Local Planning Panel

9 June 2021

15-17 William Street, Alexandria

D/2020/1059

SEPP55 - contamination

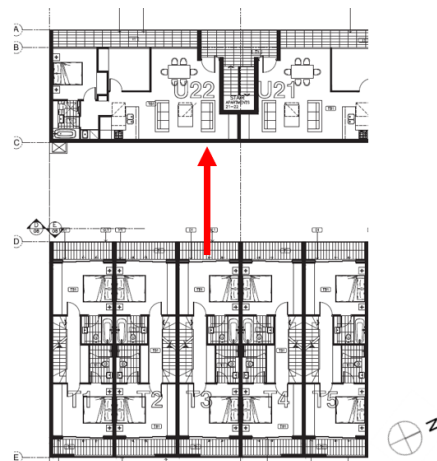
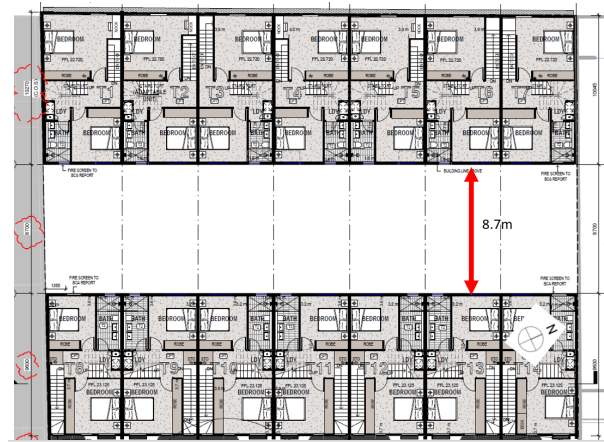
- SEPP55 not been satisfied
- applicant has failed to demonstrate site can be made suitable for residential use
- contamination statement not been reviewed by a Site Auditor

landscaping

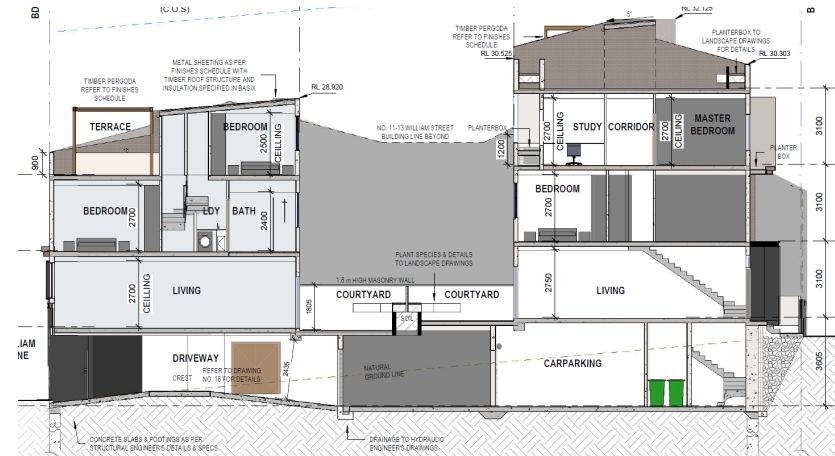
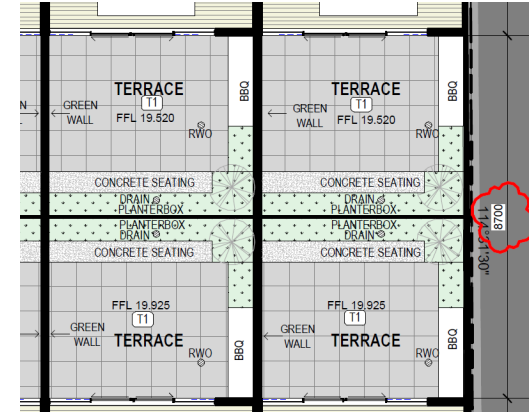
- only 5.5% inadequate site area deep soil - William Street frontage (15% required)
- planter boxes in central courtyard inadequate for substantial planting
